Modification of WLTC Ver.5

Prepared by Japan

13th DHC group
under GRPE/WLTP informal group

5 June 2012

9 points for modification

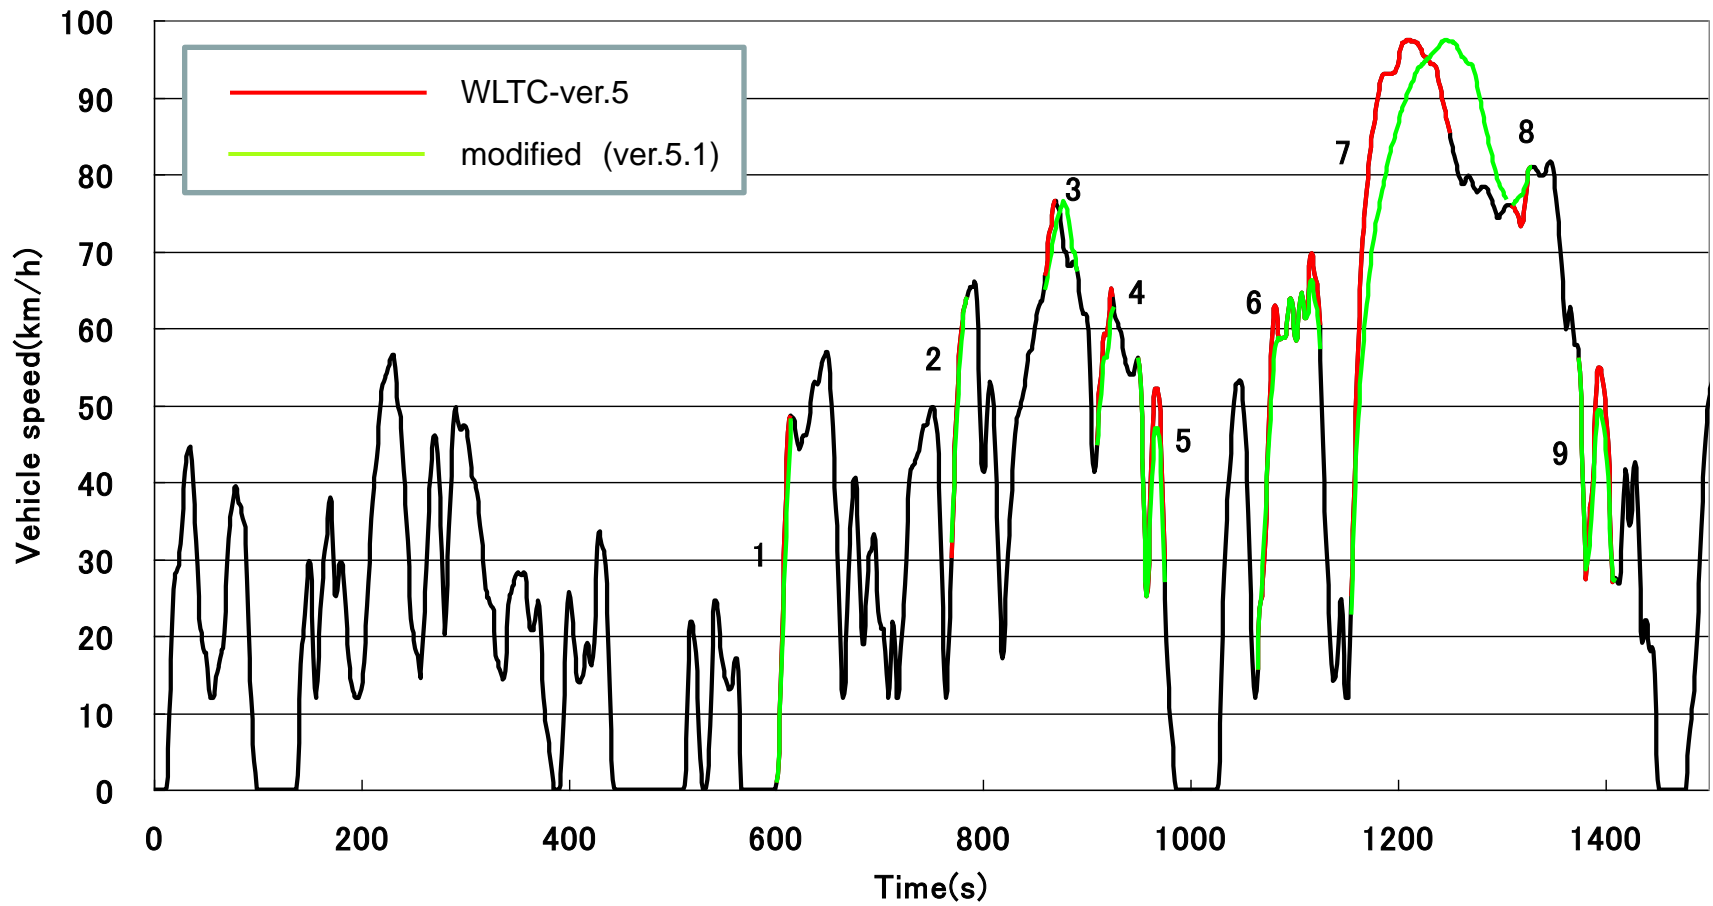
- The WLTC should be sufficiently representative for all participating regions.
- Through the validation test for WLTC-ver.5, some major vehicles ***came under the engine protection region***, in which ordinary driving rarely steps.
- The WLTC should be the cycle in which major vehicles in the current market can be operated perfectly without coming under the engine protection region.
- Japan proposes the modification of the WLTC-ver.5 to eliminate points where some major vehicles come under the engine protection region without decreasing the amount of CO₂.

On the other hand, these vehicles ***came under the engine protection region*** at many points of WLTC ver.5.

In this sense, **the cycle is far from representative cycle of usual conditions for specific major vehicles.**
